## "SLENDERNESS EFFECTS IN EARTHQUAKE RESISTING FRAMES"

- A. L. Andrews

Bulletin of N.Z. National Society for Earthquake Engineering, Vol. 10, No. 3, September, 1977.

FIGURE A

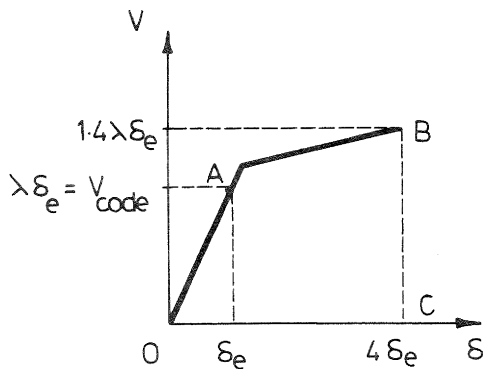
However, though the analysis is sound, its two main assumptions deserve further consideration. The first assumption is that a frame structure as a whole behaves in the elastic/perfectly plastic manner shown by Figure 3.

A more reasonable assumption for the lateral load-deflection characteristics of a frame is given in Figure A. Taking  $\lambda \delta_e = V_{code}$ , then  $V_{max} \approx 1.25/0.9 V_{code} = 1.4 \lambda \delta_e$ .

With a ductility factor of 4, and assuming the elastic part of the diagram climbs a little above  $V_{code}$ , then the work  $U_0$  done by the lateral forces is the area OABC, or

$$U_0 \approx 4.5 \lambda \delta_e^2 \quad \dots (A)$$

Adoption of the assumption of Figure A thus reduces the limitation on C given in the original paper by 3.5/4.5 so that Eq. (17) may be replaced by the constraint

$$C > 0.067/I \quad \dots (C)$$

debate with Professor Elms over the second limb of the bilinear force-displacement idealisation, whether it ought to show a positive strain hardening slope or whether a flat top corresponding with perfect plasticity is an acceptable representation for our purposes. Were I to need justification for my choice I might have found it in the general endorsement given to practical ideas which rely on the relevance of the flat top for their validity. Among these are the collapse assessment procedures of the plastic method for steel frames devised by Baker's Cambridge team<sup>(7,8)</sup> and the procedure earthquake engineers use to reduce elastic response forces to design forces by division by the numerical equivalent of a displacement ductility factor<sup>(9)</sup>. It might have been unwise to infer from the success of these and of other widely used "flat top" dependent ideas that it is generally reasonable to ignore the strain hardening slope which sometimes appears, although not always as noticeably as in Professor Elms' illustration; but the discussor's conclusion that there is nothing very significant to be had from this refinement makes it unnecessary to pursue the matter.

FIGURE B: LOSS OF WORK CAPACITY FOR  $I = 1, \mu = 4$

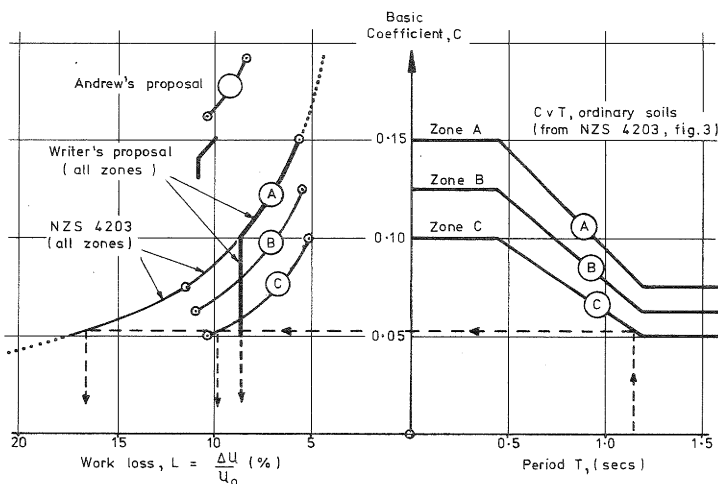
This result is plotted in Fig. B against  $T$ , where the T-C relationship is that of Figure 3 of NZS 4203.

From (17A), clearly  $L$  will only be less than 10% of the work intended to be expended when  $C$  is greater than .0857. While the author suggests new zone-dependent stiffness controls to keep the P- $\Delta$  losses to less than 10%, the losses are C-dependent rather than zone-dependent. It would be more appropriate for the code stiffness control clause to maintain the present absolute limit of 0.01.h for its damage control purpose, and to introduce a further limit of 0.1 C.h for control of P- $\Delta$  losses. This would have the effect of restricting P- $\Delta$  work loss to a consistent 8.57%, independent of zone or the particular code's pseudo-spectrum.

Mr. Buchanan proposes a modification to the paper's flexibility limiting proposal; but one which is more complex and which, on that account, will probably find less favour with designers. We have now complexity enough to contend with. What I see to be needed is a control, the simpler the better, which will halt dangerous pursuit of the specious advantage of slenderness by designers of buildings for seismic zones B and C.

FIGURE C: SINGLE DEGREE OF FREEDOM SYSTEM

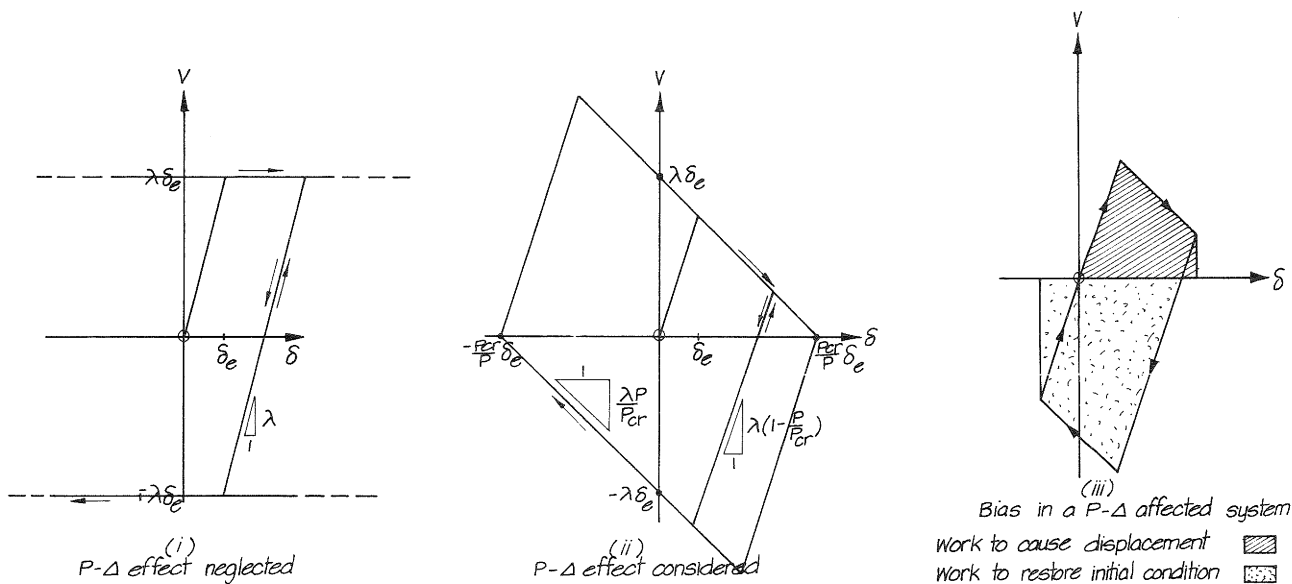
Mr. Andrews' paper is on a static basis - as is the Code's primary approach to seismic design. It is well recognised that this is a poor representation of the real dynamic behaviour. It is clear from Fig. 4 of the paper that a deflected structure must rise to recover its original position, which immediately suggests that there will be a tendency for flexible or ductile structures to deflect further rather than to recover the energy lost. Does the author anticipate dynamic effects being significantly different from those covered by his static analysis?

I had considered dynamic effects; but did not report this in the paper because the work was (and still is) incomplete. We can forecast the probable result from a dynamic study. Figure C (ii) shows a completed behaviour limit diagram for a single degree of freedom structural system with the kind of idealised material behaviour previously considered. Within the limits represented by lines sloping negatively at  $\frac{\lambda P}{P_{cr}}$ , the system has Masing

type behaviour of the kind customarily assumed for all earthquake resisting structures. These limit lines cross the zero displacement axis at lateral resistance  $\pm \lambda \delta_e$ . The slope of elastic behaviour lines is  $\lambda(1 - \frac{P}{P_{cr}})$ . Limit lines intersect the zero lateral resistance axis at two points  $\pm \frac{P_{cr}}{P} \delta_e$ . These points are static collapse or catastrophe points.

Figure C (iii) shows how the work required to cause a displacement from the original undisplaced position is less than that needed to restore the structure.

Deformation of the structure is therefore biased in the direction of first significant yield. Every framed structure subject to excitation causing responses which exceed elastic limits is certain to collapse from this cause if the excitation is maintained for a long enough time. Thus, it may well be that P-delta considerations are more significant than the simple static consideration shows.
